N4691D-02

# Modification Recommended Service Note

## N4691D Electronic Calibration Module (ECal)

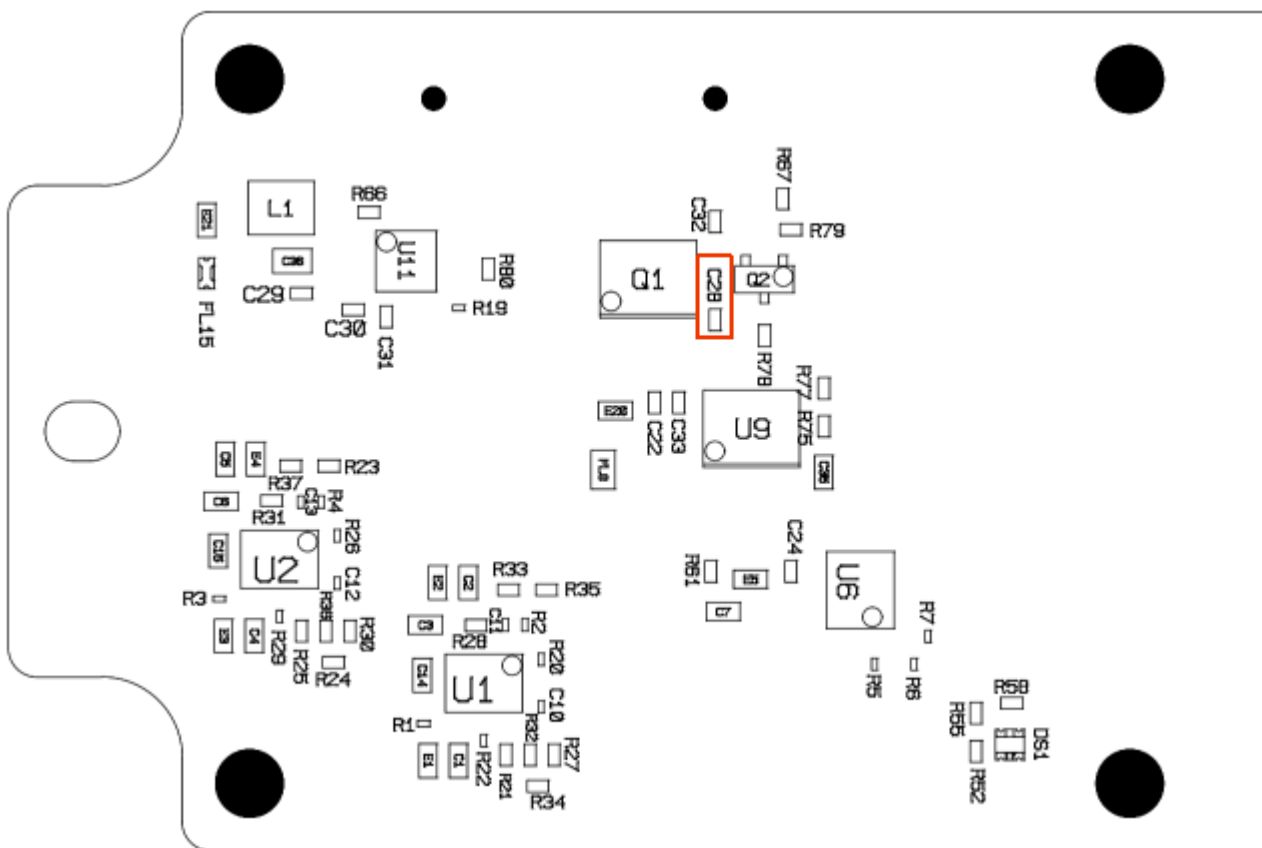
The heater circuit in the N469xD ECal modules was initially designed with a dampening capacitor. It was found in a small number of ECal modules that a resonance can develop in this circuit after the modules is warmed up. This resonance can cause an RF tone between 140 MHz and 150 MHz to be injected onto the signal path.

The dampening capacitor was eliminated in all ECal modules with serial prefix MY5941 and above.

Open the ECal module and remove the N4690-63004 printed circuit board. On this board, locate the C28 capacitor indicated here:

If this capacitor has been removed, no further action is required. Reassemble the ECal module.

If this capacitor exists on this board, this capacitor should be carefully unsoldered and removed, or the N4690-63004 printed circuit assembly should be replaced. Once this is done, reassemble the ECal module.
